**HISTORIC PRESERVATION REVIEW BOARD
STAFF REPORT AND RECOMMENDATION**

Landmark/District: **Capitol Hill Historic District**
Address: **425 4th Street NE**

Meeting Date: **December 21, 2023**
Case Number: **24-046**

Jennifer Fowler, agent for property owners Lis Kidder and Daniel Spurlock, seeks conceptual design review for construction of a 3-story addition to a contributing building in the Capitol Hill Historic District.

Oblique aerial view (2015) showing 425 4th Street NE (red dot at center) and neighboring doglegs

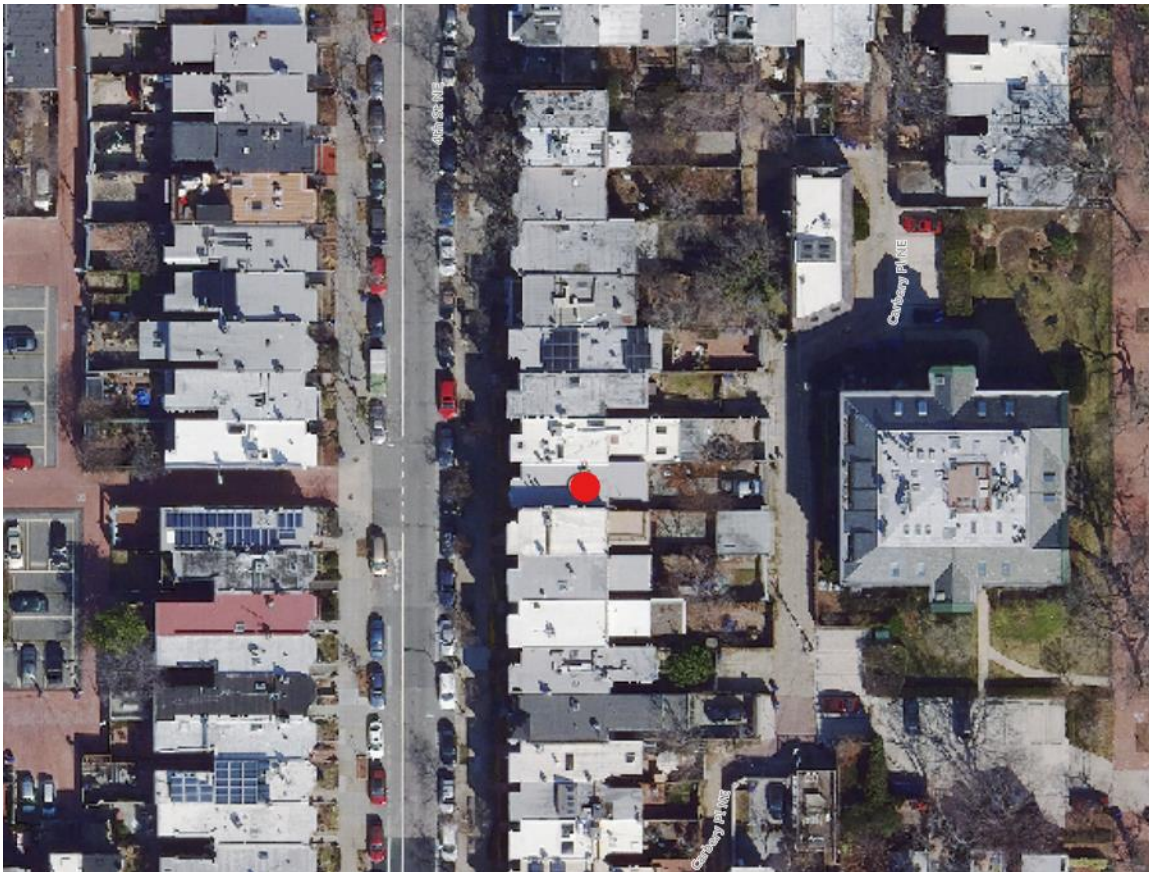
The dogleg will remain at the second floor. So, for an observer in the alley whose view of the first floor is mostly blocked by garages and fences (in the rear, the cellar is fully below grade), the form of the dogleg will remain intact and in view. The most visible portion of the third floor above the dogleg will not be brick, like the second floor, and so will create a distinct transition. Currently, 67% of the rowhouses fronting 4th Street NE on this block contain doglegs. The existing rhythm of those doglegs, which are mostly concentrated midblock, will not be dramatically changed by this project for two primary reasons: 1) the proposed third floor has a rear setback of 5' and will be of different materials to demonstrate distinction from the original, and 2) the existing dogleg rhythm has previously been disrupted. Neighboring rowhouses have added roof decks and rear extensions that have caused imperfections in the height and rear alignment of the doglegs. Other blocks of Capitol Hill, including on the opposite side of 4th Street NE, contain far better-preserved rows of visible doglegs (see aerial and oblique images below).
